# Brent Cross Cricklewood Development

Area Wide Walking and Cycling Study: Addendum 60473918-TP-RPT-091 Rev 002

Appendix A.A406 TEMPELHOF BRIDGE: DRAWING BXCR-URS-B1-HS-AP-SE-00001

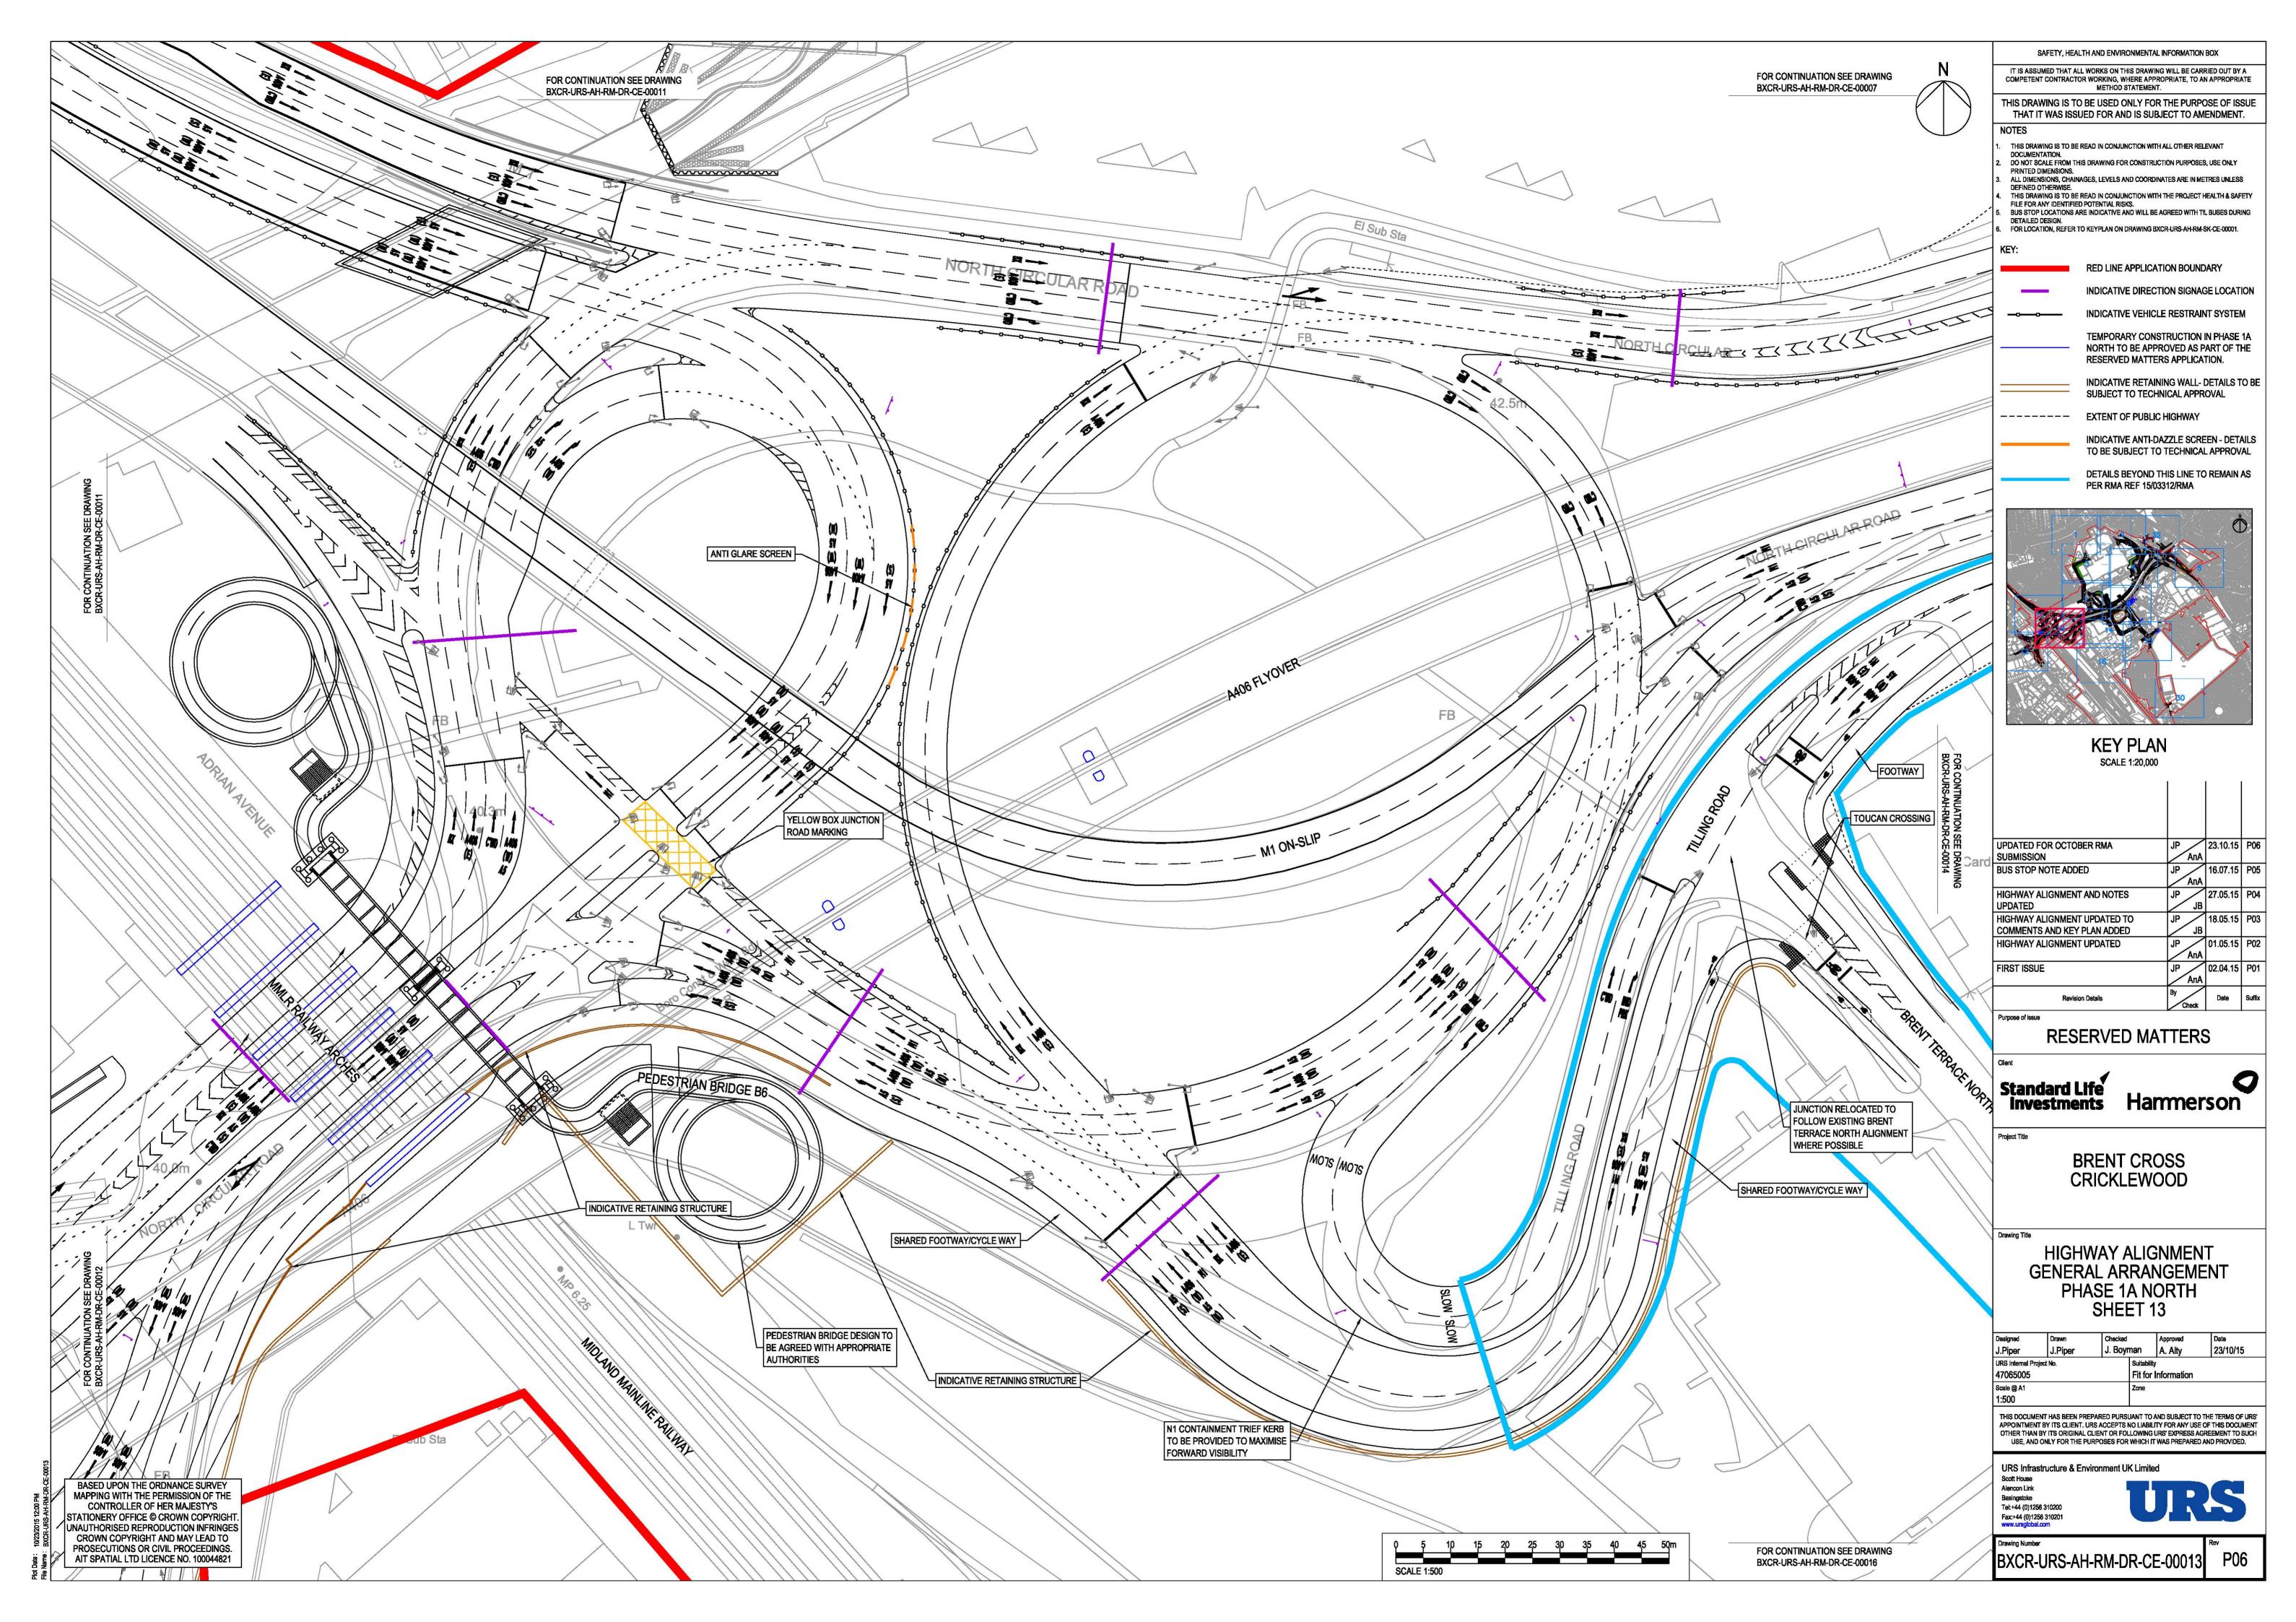
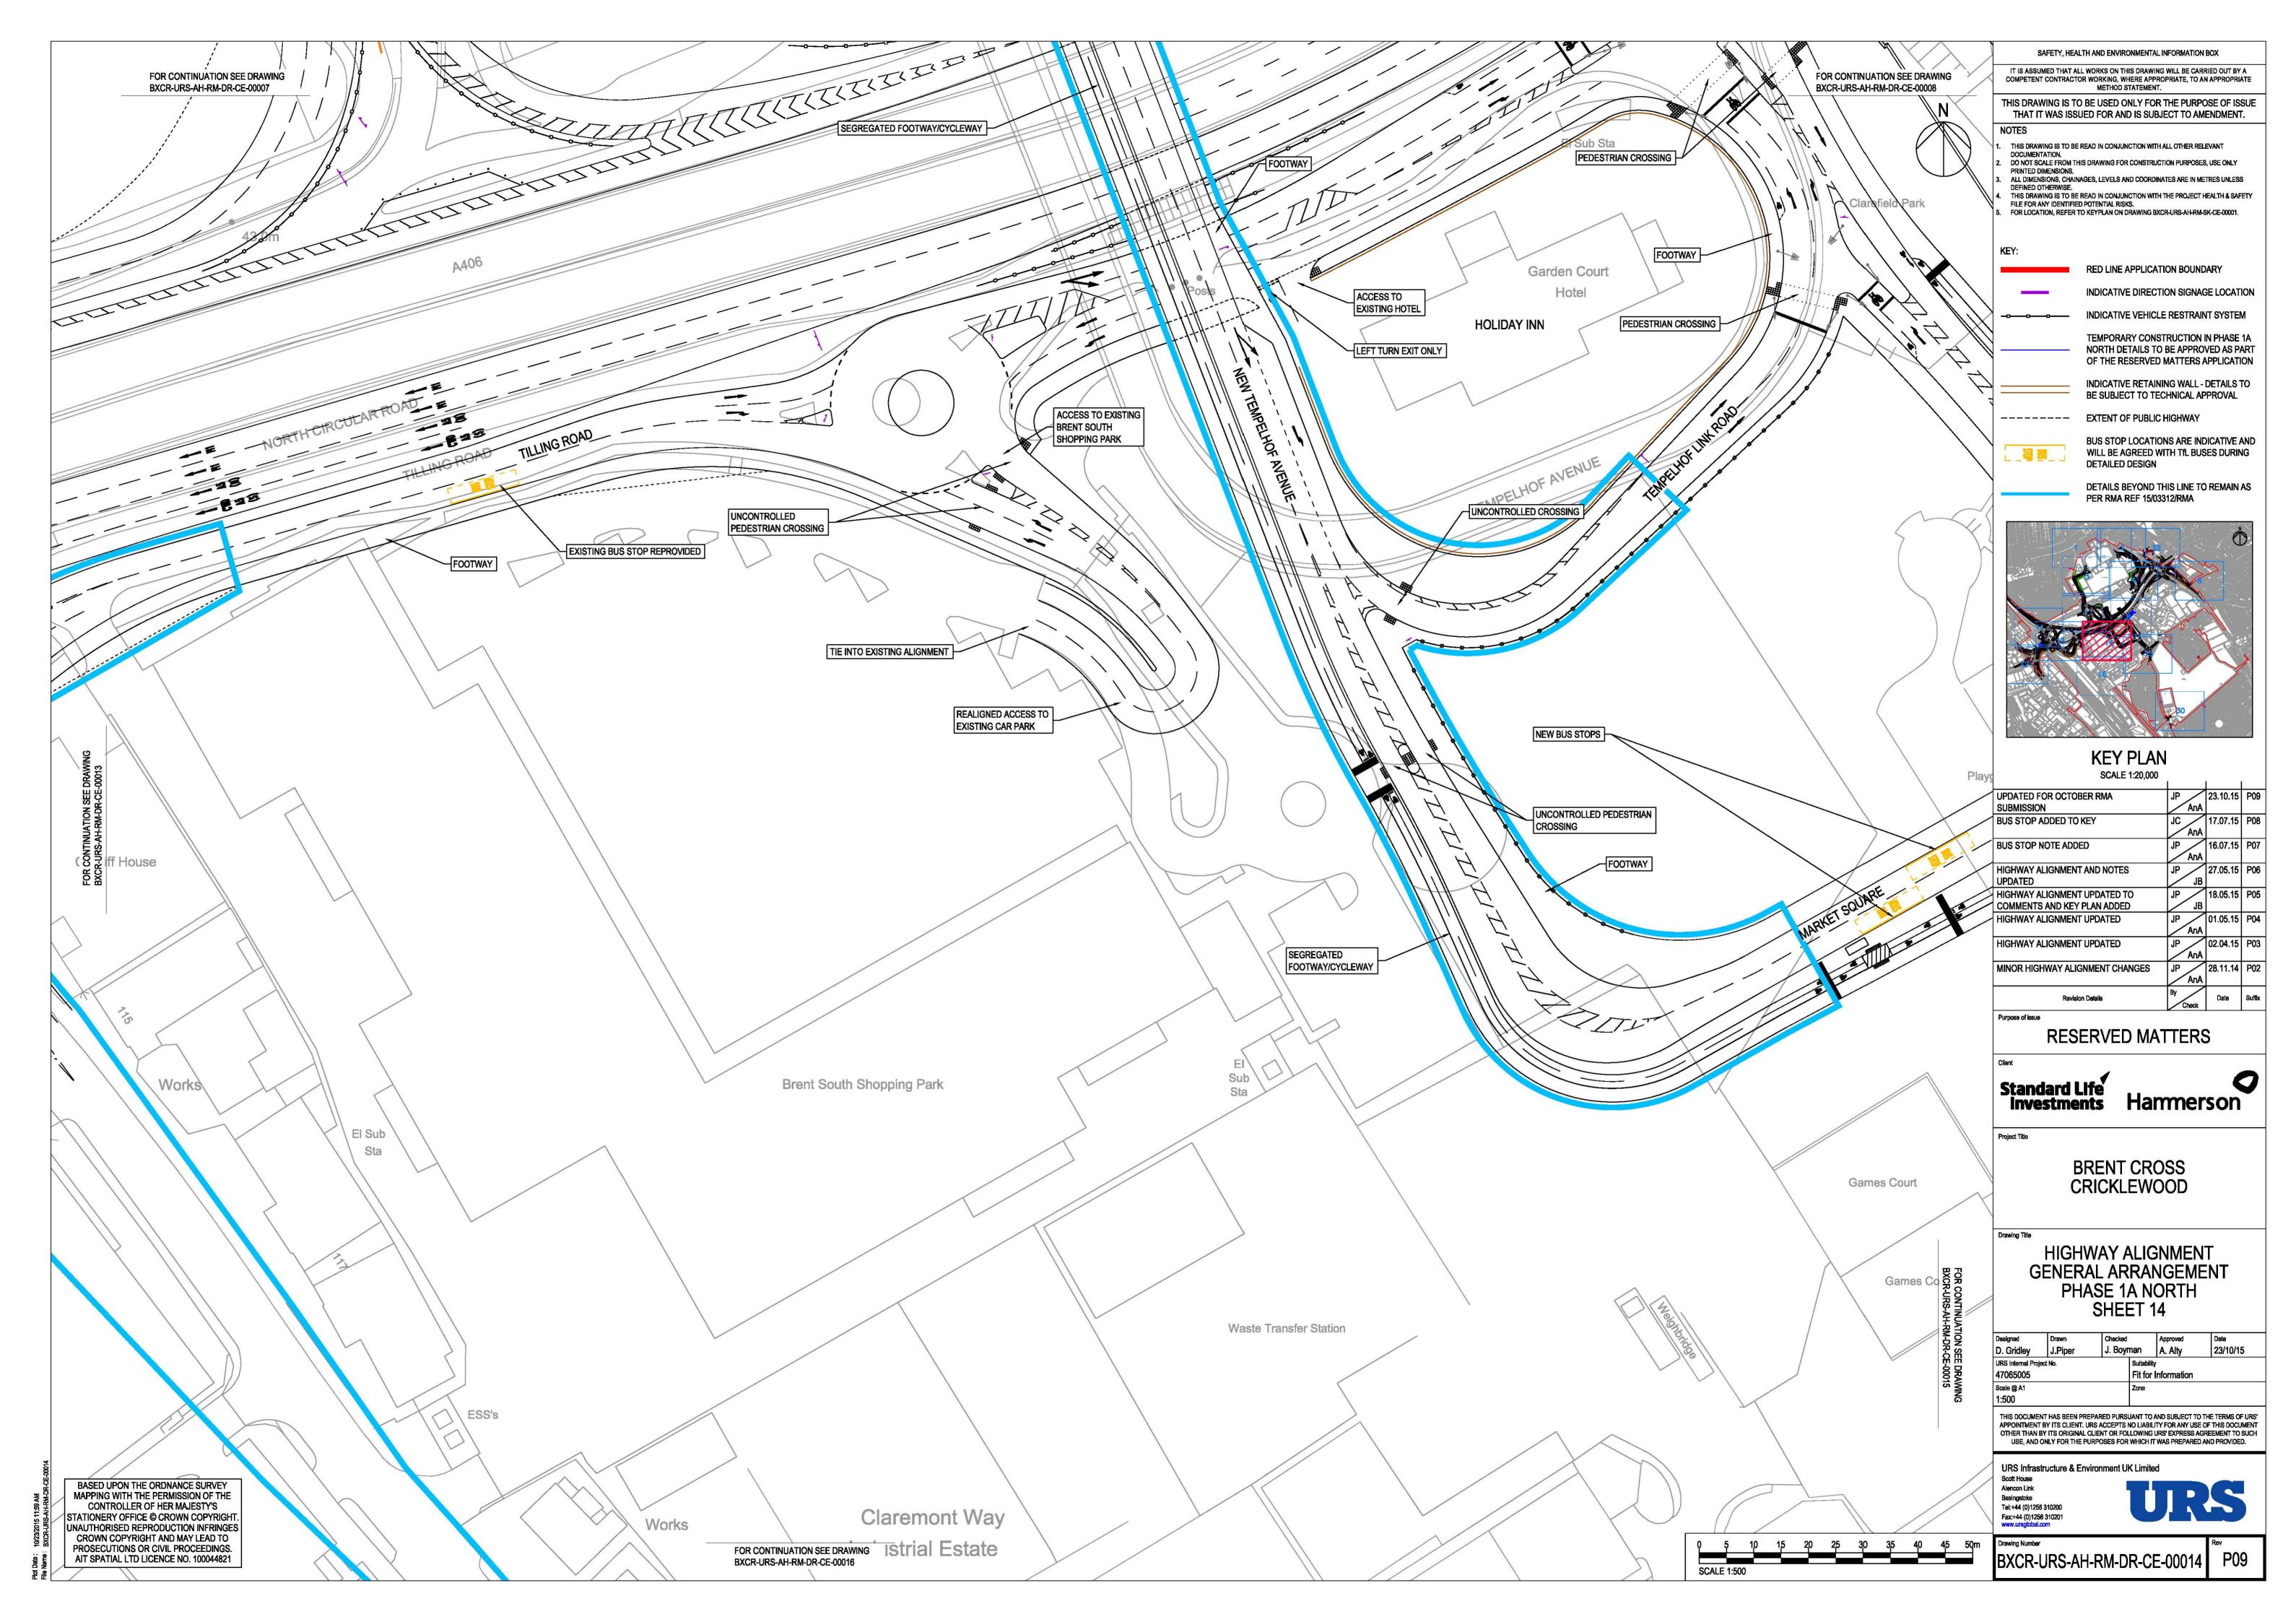
The Development Partners are investigating an alternative proposal for the specification for this bridge from that shown in the approved RMA so as to provide a replacement bridge which would include only one general traffic lane in each direction, rather than two lanes in each direction which allows for bus lanes as in the approved scheme.

The alternative proposal, which was submitted under Reserved Matters Application Ref No 15/06571/RMA in October 2015, includes proposed amendments to the approved highway alignment as set out above. The alternative proposal includes the provision of a narrower overall bridge structure, reducing the number of traffic lanes from four to two, by removing the two dedicated bus lanes. The alternative proposal will reduce the construction complexity and therefore reduces the potential temporary impact to the travelling public.

As per the approved highway alignment a slip lane would be provided for southbound traffic to filter into the Tempelhof Link Road.

The two approach structures will be constructed in a number of stages to ensure that the new highway alignments tie-in satisfactorily to the alternative proposals.

### Appendix C. AWWCS DRAWING 47066786/AWWCS/003 REV D

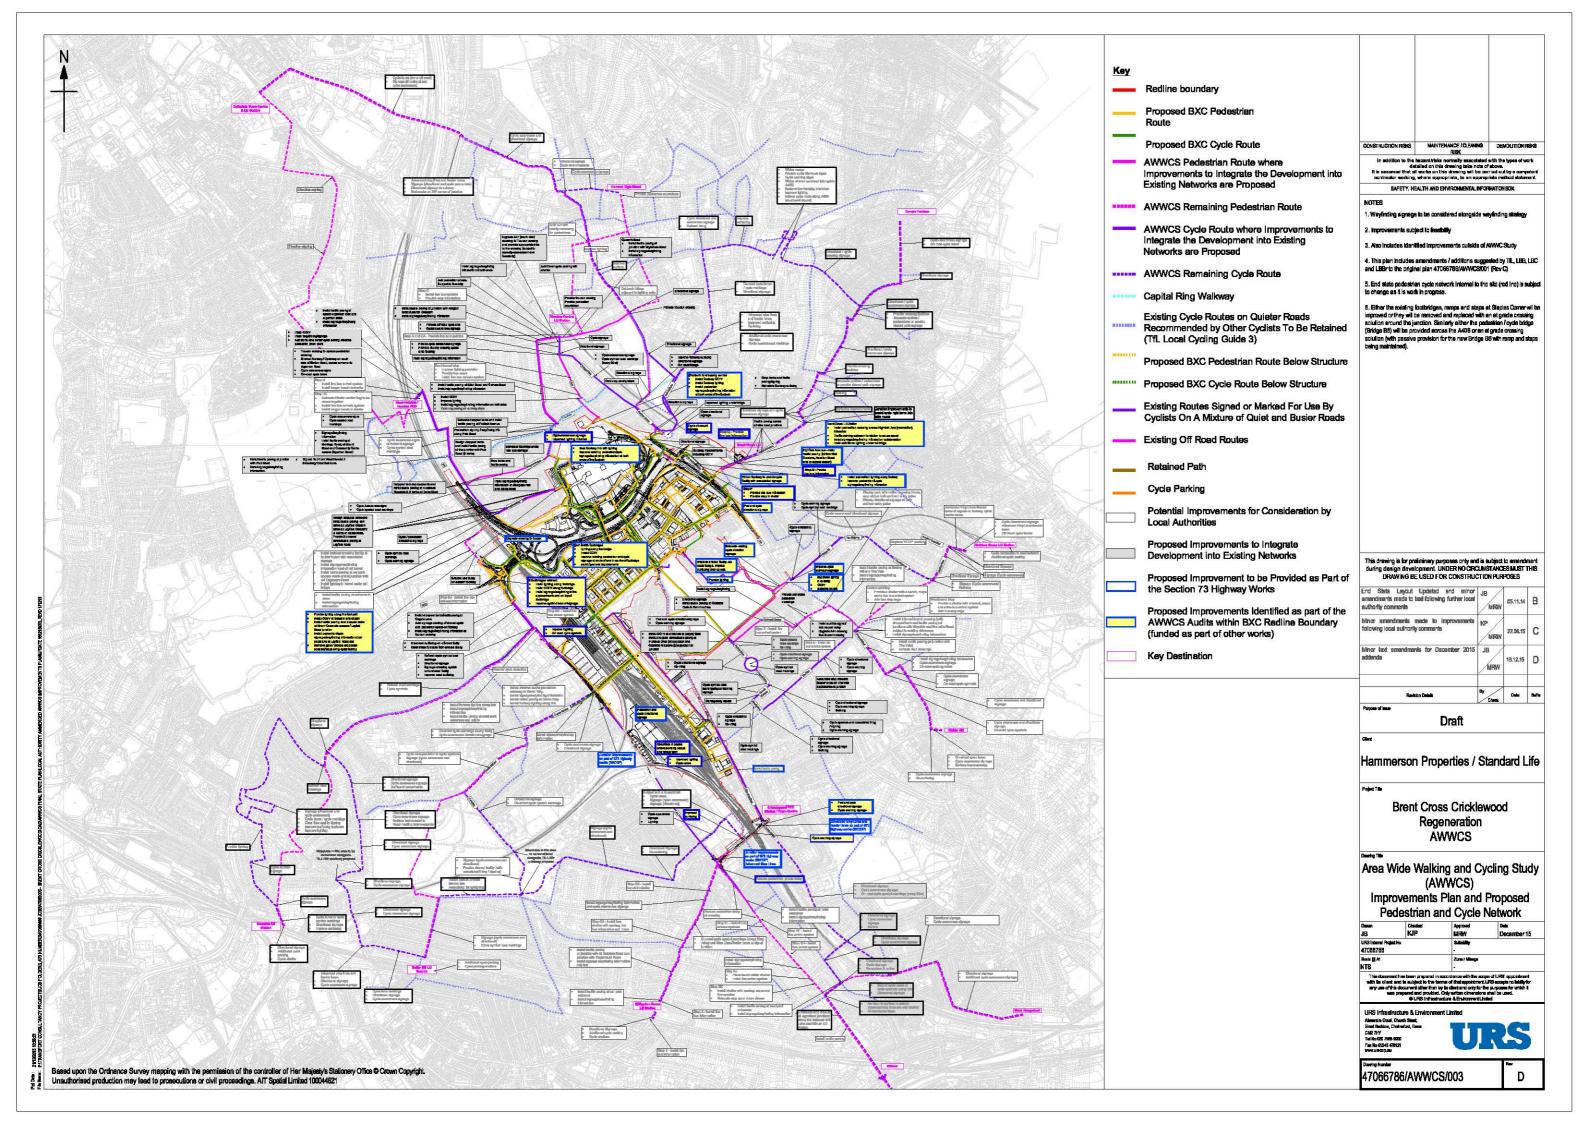
- Appendix A of AWWCS Addendum 47065005-TP-RPT-070 Rev 1 Drawing '47066786/AWWCS/003 Rev C' to be replaced with '47066786/AWWCS/003 Rev D'. The revised (Rev D) drawing can be found in **Appendix C** of this Addendum. The following changes have been made to this drawing in Revision D:

- Note 6 to be added to the Notes section of the drawing: "either the existing footbridges, ramps and steps at Staples
    Corner will be improved or they will be removed and replaced with a series of at-grade toucan crossings around the
    junction. Similarly either the pedestrian/ cycle bridge (Bridge B6) will be provided across the A406 or a series of atgrade toucan crossings are proposed"

- Add text prior to list in yellow box with yellow edging pointing to Staples Corner junction stating "If footbridges retained"
  - Convert grey box pointing to A5 north of Staples Corner to yellow box with blue edging
